**MITCHELL PARK HORTICULTURAL CONSERVATORY
DOMES
Peer Review**

Final Report

March 14, 2017

National Trust for Historic Preservation

Figure 9. Section through hub from original drawings showing hub cladding drainage system

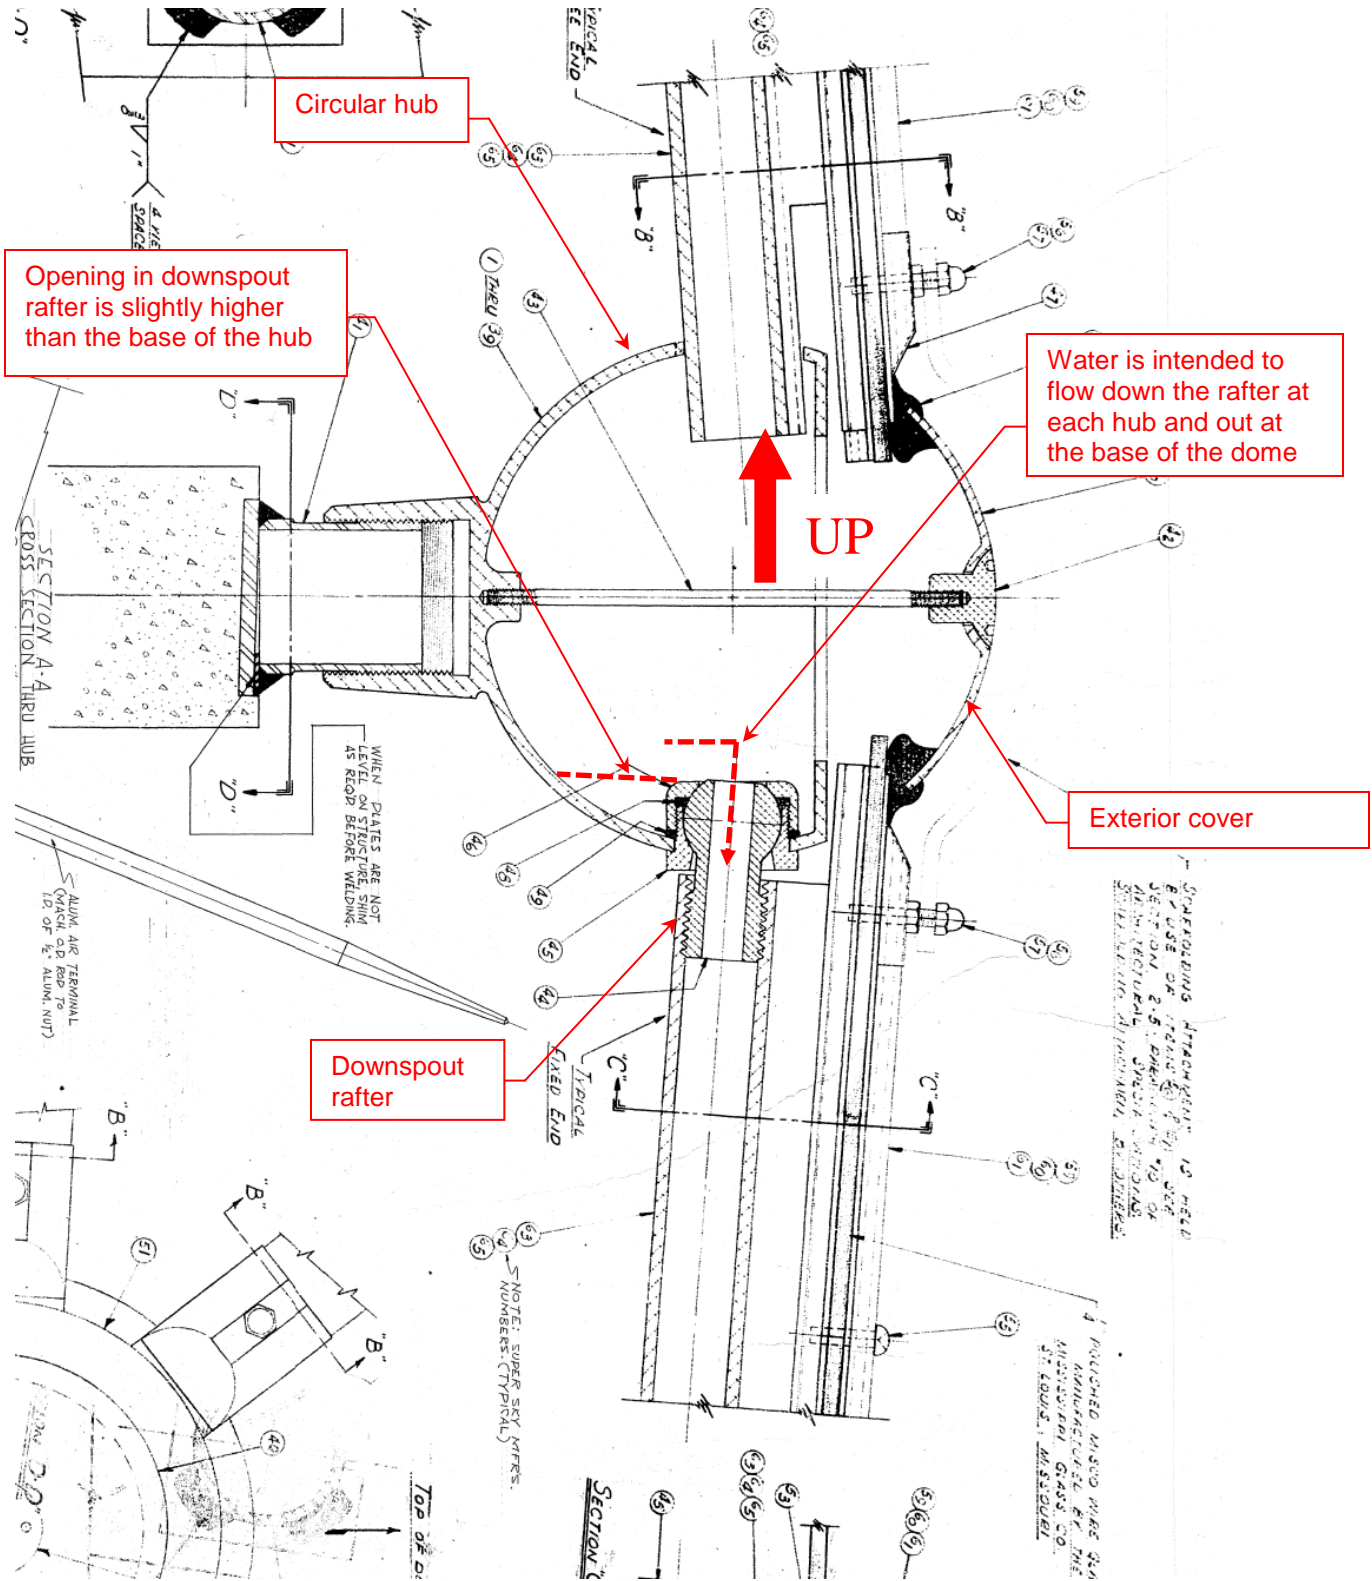
- GRAEF reported that water leakage throughout the domes has historically been a problem and still remains an ongoing issue. GRAEF reported that water was observed sitting in the hub and not allowed to drain. They attribute this problem as due to the fact that the downspout rafter extends higher than the base of the hub (see Figure 9).

Figure 12. Netting and cables in Show Dome

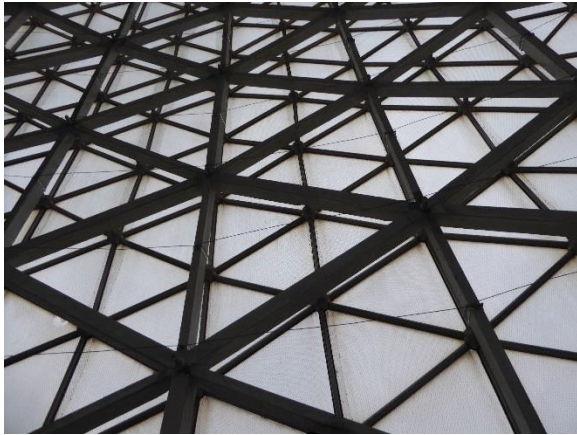
1. Mesh netting secured to the precast framing with cables was observed in the Show Dome (Figures 12 and 13). The netting was in the process of being installed in the Arid Dome.

- The wire mesh could be removed after the repairs are completed to address water infiltration and spalling at embedded plates. Removing the wire mesh would require regular inspections and maintenance repairs to be completed as necessary. However, the mesh does provide a safety barrier against spalling concrete that has occurred in the domes.

Figure 15. Removed spall at connection location. Note: connection is painted with blue colored coating.

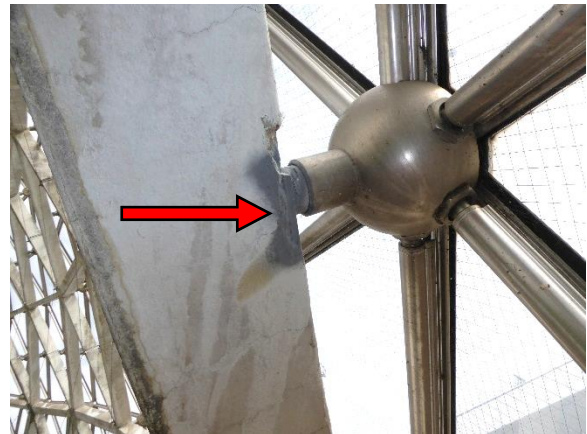
3. Concrete spalls had been removed at several embedded connections where the hub from the glass cladding is supported by the precast framing (Figures 14 and 15). The embedded plate was painted at the location of removed spalls.

1. Remove delaminated concrete at embedded plates, and clean and paint the plates. Proactively removing potential spalls at connection plates could be performed, but may not be necessary if the netting remains in place. If removing the netting is desirable, we recommend proactively removing potential spalls at embedded connections.
2. Repair concrete spalls with exposed reinforcing steel within the body of the precast member.
3. Repair deteriorated areas of grout.
4. Clean and paint the concrete with a coating system capable of bridging over cracks. Some cracks and joints may need to be stripe coated or sealed prior to the coating installation.

Figure 16. Removed spall within the body of the precast element. Note: concrete and reinforcing steel was painted with a blue colored coating.

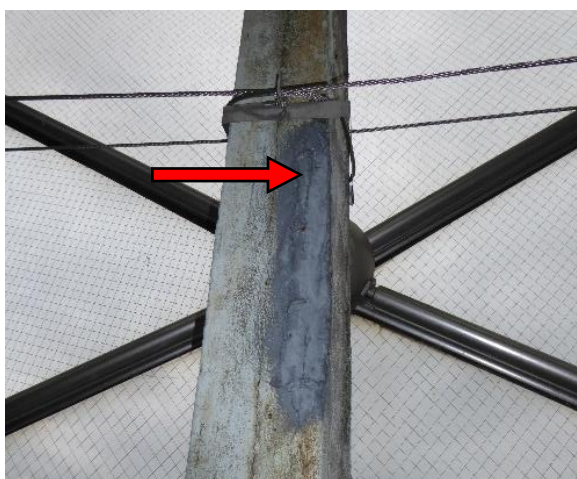
4. Concrete spalls, previously removed, were observed within the body of the precast concrete member, exposing reinforcing steel at a few locations in the Arid Dome (Figures 16 and 17). The reinforcing steel appeared to have minimal concrete cover.

Figure 24. Black build-up on downspout rafter fitting at water leakage location

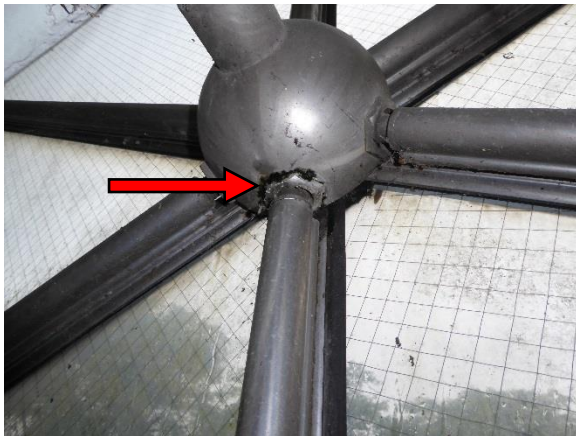
1. Cracked glass units were observed at several locations (Figures 20 and 21). Some of the cracked glass appears to be the result of impact.
2. The glazing material that separates the glass from the pressure caps has deteriorated over time. This is a likely source of water infiltration into the domes (Figure 22).
3. Sealant was installed around the hubs at several locations at the base of the domes (Figure 23).
4. Leakage was observed at approximately six locations in the Arid Dome at the connection of the hub to the downspout rafter. At locations where leaks were observed, the downspout rafter fitting had visible black material build-up, which seems to be an indicator of a leak location (Figure 24).

Figure 25. Section through glass and aluminum frame showing conceptual pressure cap repair for consideration

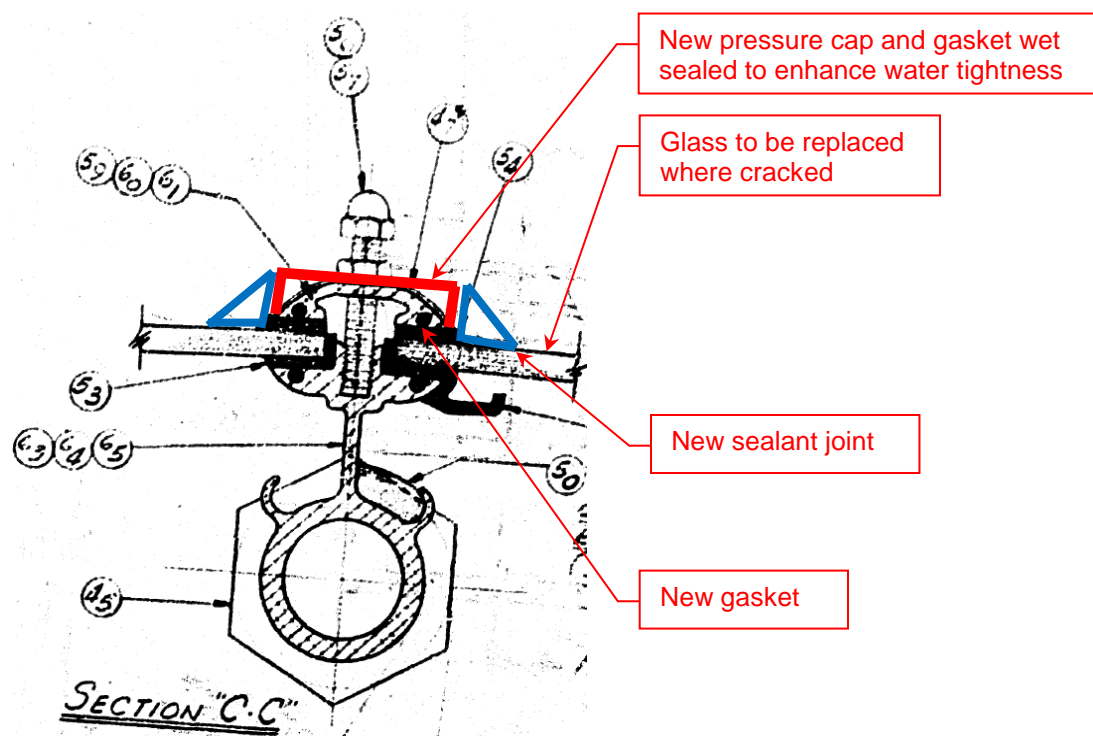
- For weather protection, WJE would normally recommend resealing the glass to aluminum joints around the dome. This is usually performed by a "wet seal" between the glass and the exterior aluminum (the pressure cap). In this case, however, the edges of the existing pressure caps are thin. Obtaining an adequate wet seal joint between the pressure cap and glass would be difficult. As an alternative, removing and replacing the pressure cap with a new redesigned pressure cap would allow for additional weather protection by: a) replacing the exterior glazing seals between the glass and the pressure cap with new glazing seals, and b) a thicker edge detail on the new pressure cap, which would allow a wet seal to supplement the new glazing seal. We believe that this redesign would largely resolve rain water leakage through the dome. We believe that this is a practical step for GRAEF to consider as an addition to their Option 1 repair.

1. Replace existing cracked and broken wired glass in kind, or with laminated glass. Modifications in the glass replacement design could be implemented based on the findings from further investigation and mock-up repairs.
2. Remove and replace all pressure caps and wet seal joints (Figure 25).
3. Clean hubs and install self-leveling sealant at leading hubs (Figure 26).
